UNITED STATES
NUCLEAR REGULATORY COMMISSION
WASHINGTON, D.C. 20555-0001

SUBJECT: ISSUANCE OF AMENDMENTS (TAC NOS. M83108, M83109, AND M83110)
(TS 301)

The Commission has issued the enclosed Amendment Nos. 199, 216, and 172 to Facility Operating License Nos. DPR-33, DPR-52 and DPR-68 for the Browns Ferry Nuclear Plant, Units 1, 2, and 3, respectively. These amendments are in response to your application dated March 25, 1992, and supplements dated January 29, 1993 and August 27, 1993.

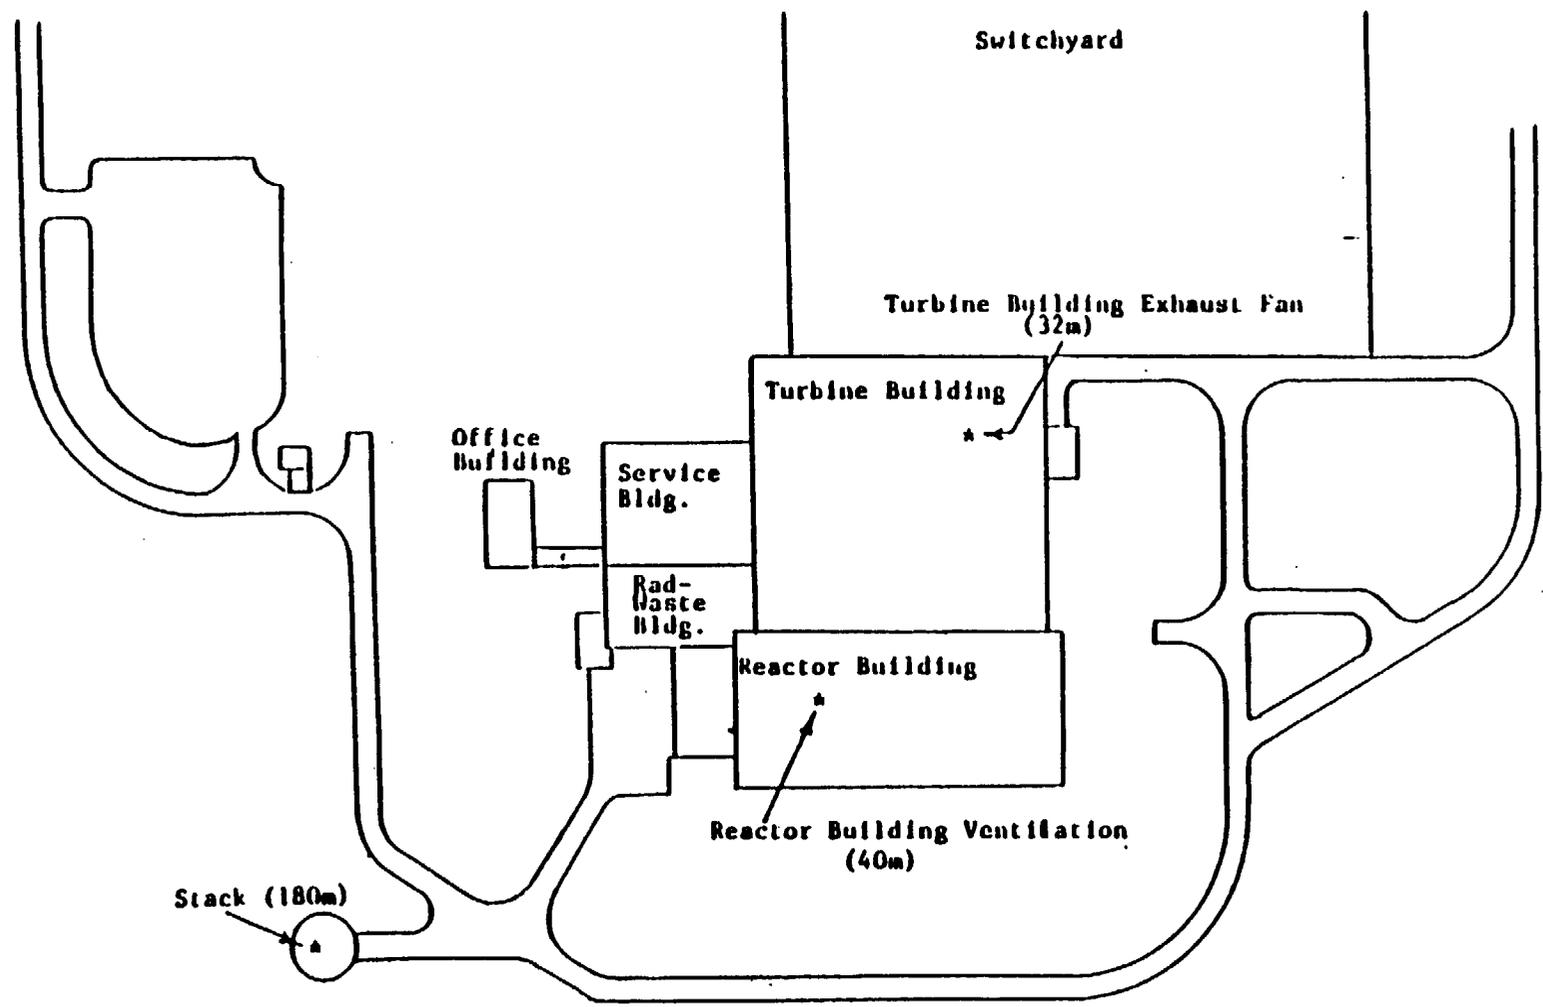
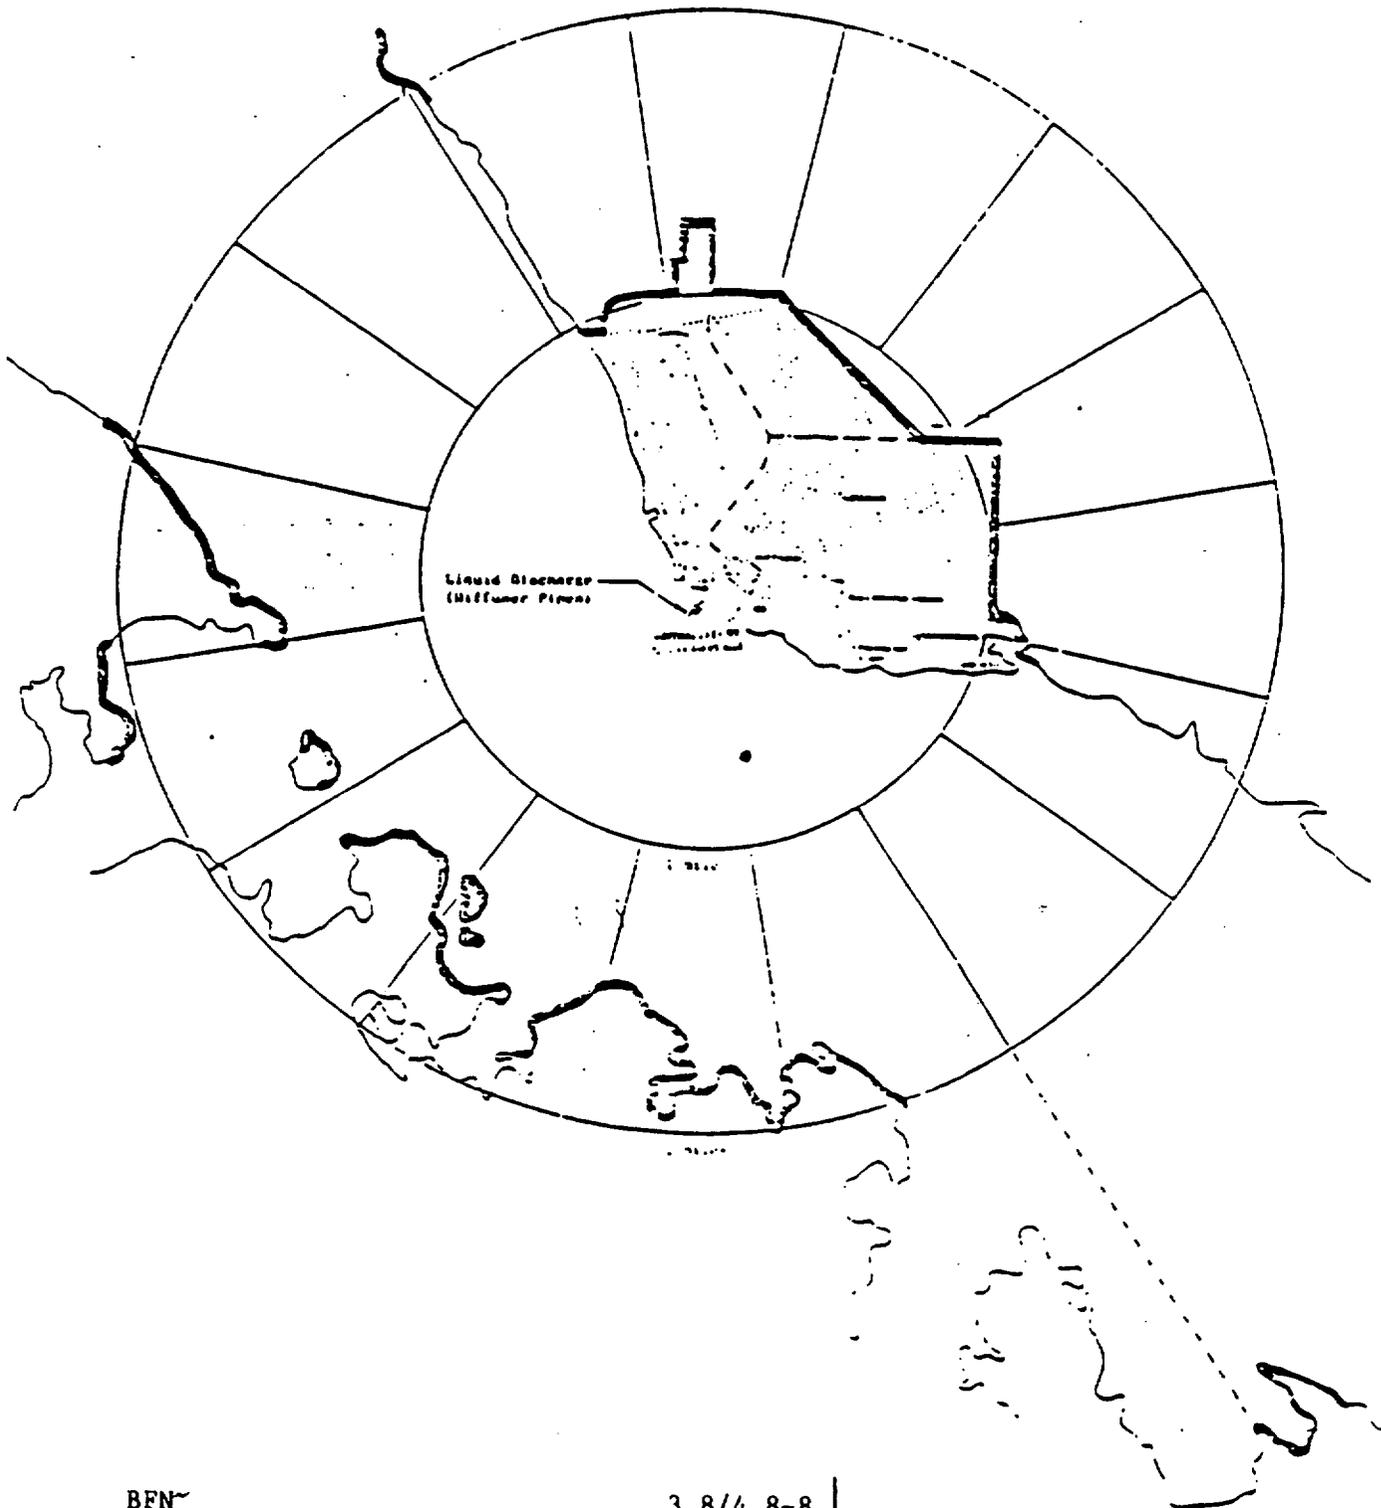
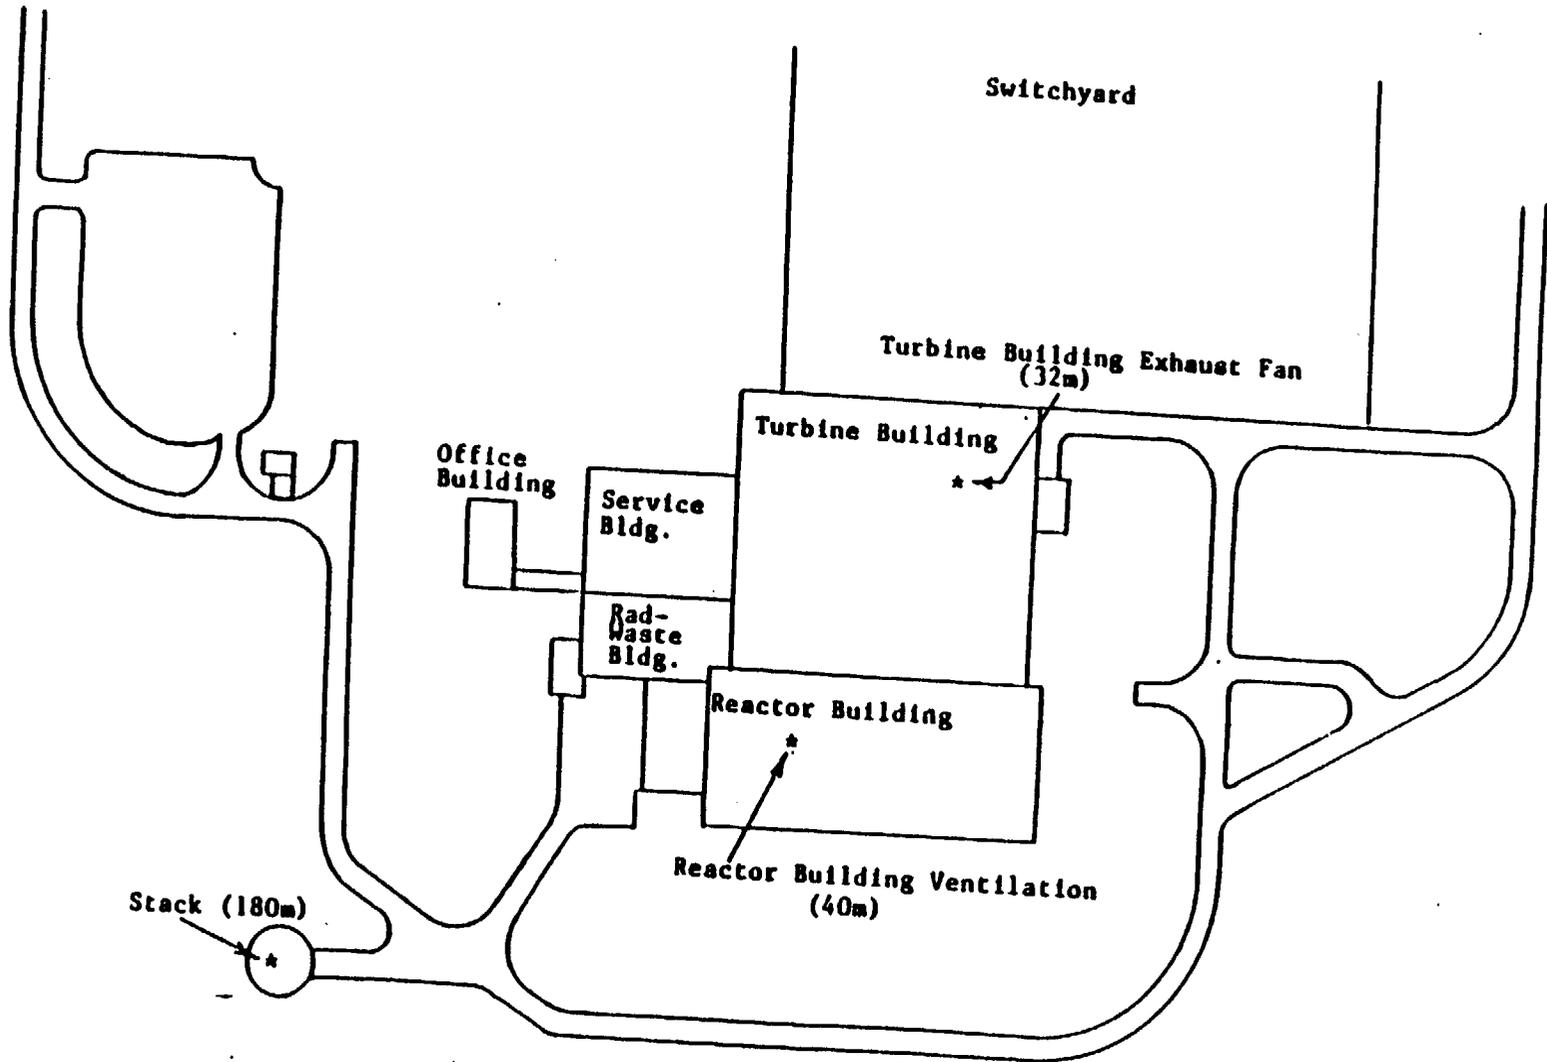
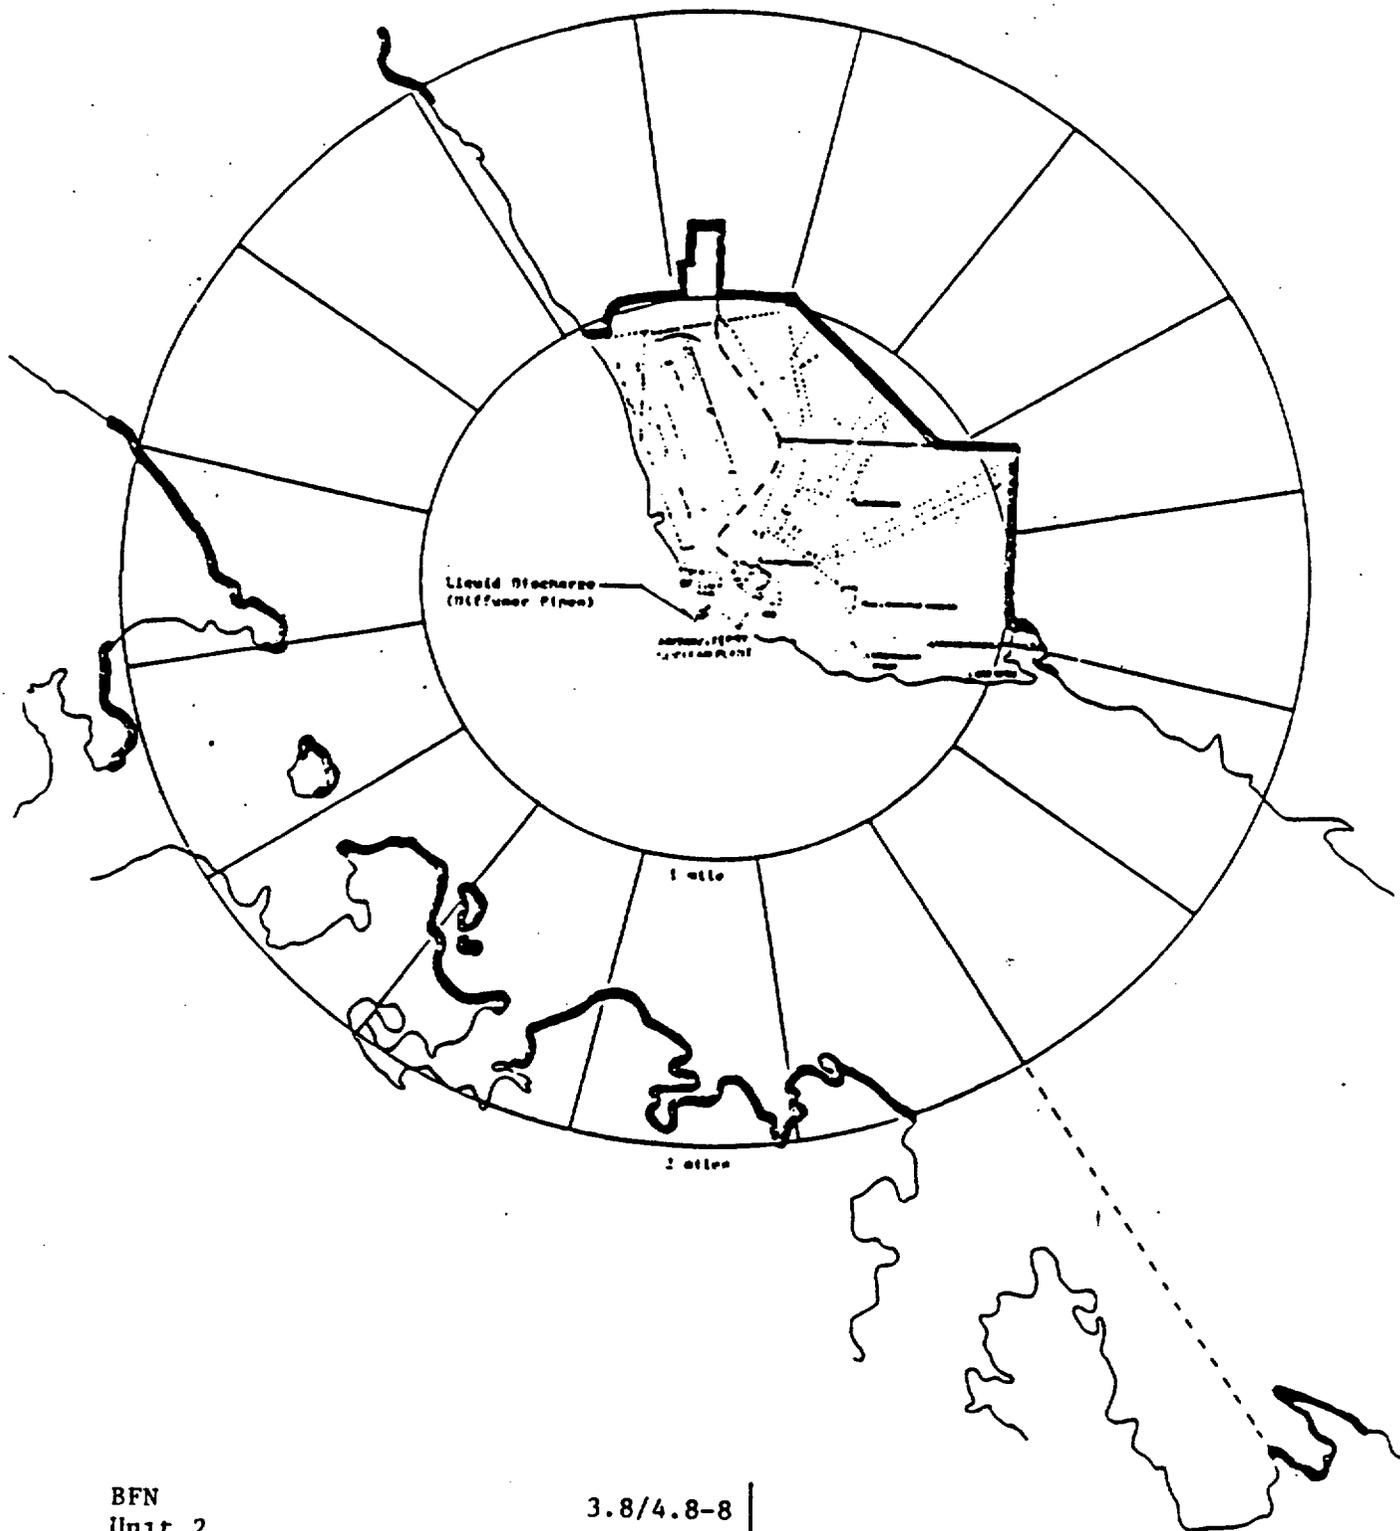
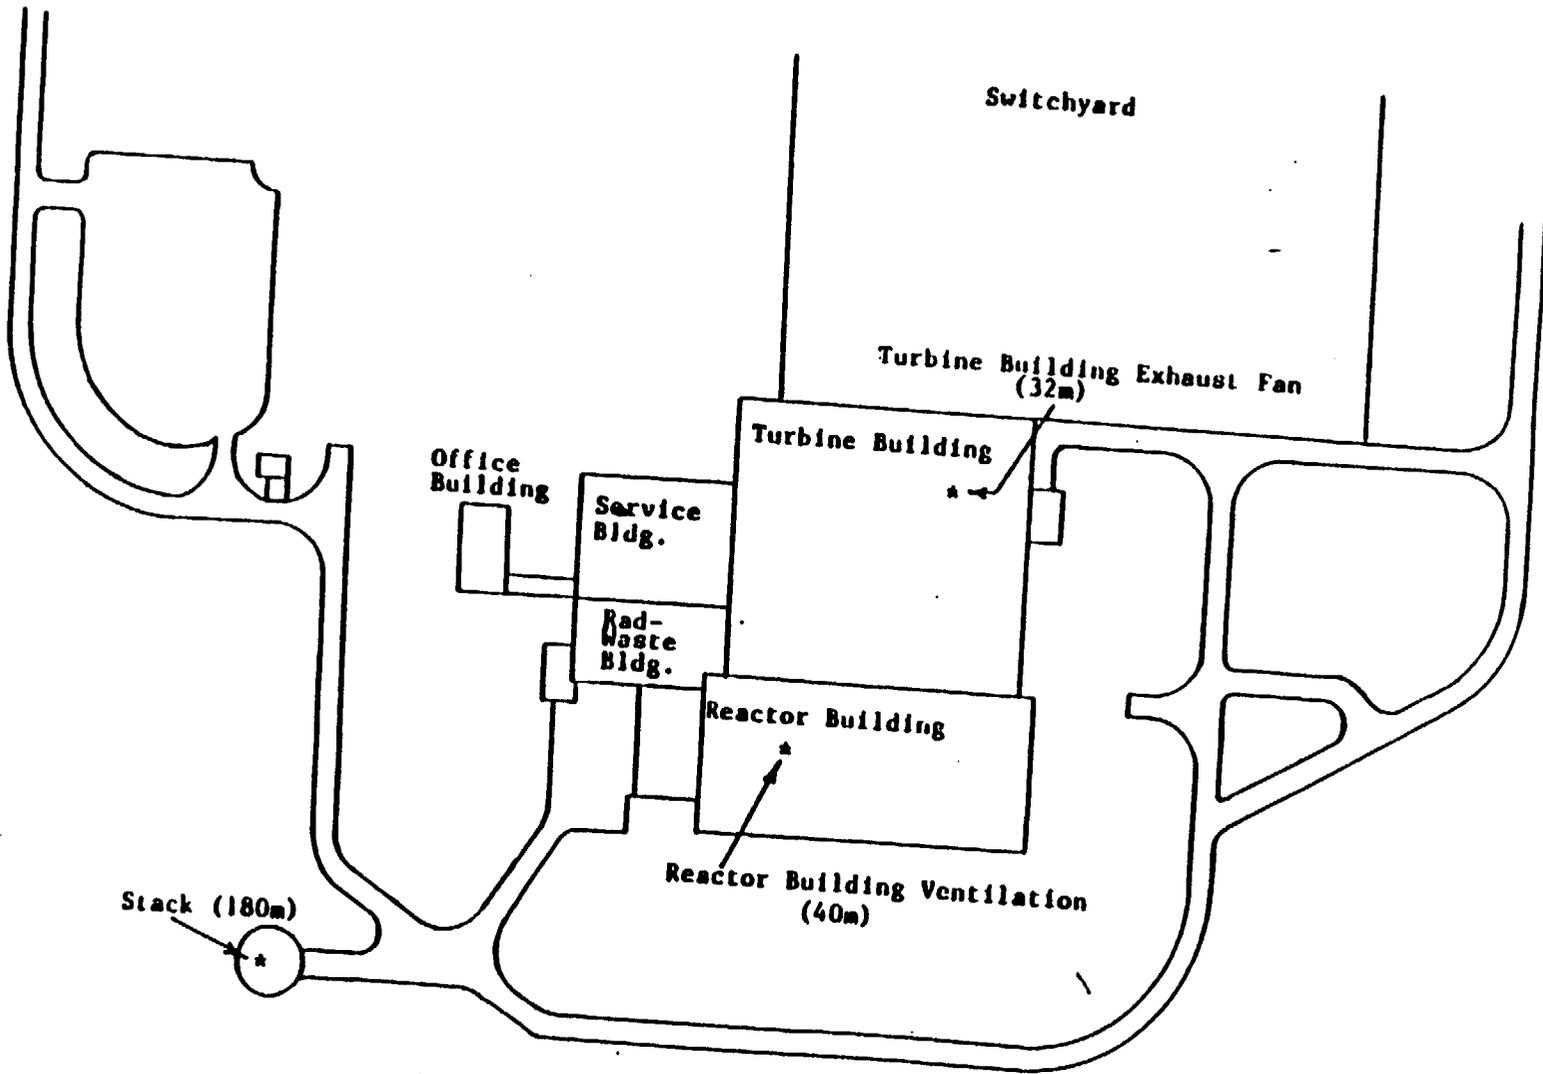
<u>SPECIFICATION</u>	<u>TITLE</u>
1.0.BB	ODCM
1.0.DD	PROCESS CONTROL PROGRAM
Figs. 4.8-1 a&b	GASEOUS RELEASE POINTS & LAND SITE BOUNDARY
3/4.2.K	EXPLOSIVE GAS MONITORING INSTRUMENTATION (Retained existing requirements of this specification with revised bases) (Refer to section 2.2 below for further detail)
3.8.A.5,6 4.8.A.6	LIQUID HOLDUP TANKS (WITH BASES ADDED)
3.8.B.9,10 4.8.B.5	EXPLOSIVE GAS MIXTURES (WITH BASES ADDED)
3/4.8.D	MECHANICAL VACUUM PUMP
3/4.8.E	MISCELLANEOUS RADIOACTIVE MATERIAL SOURCES
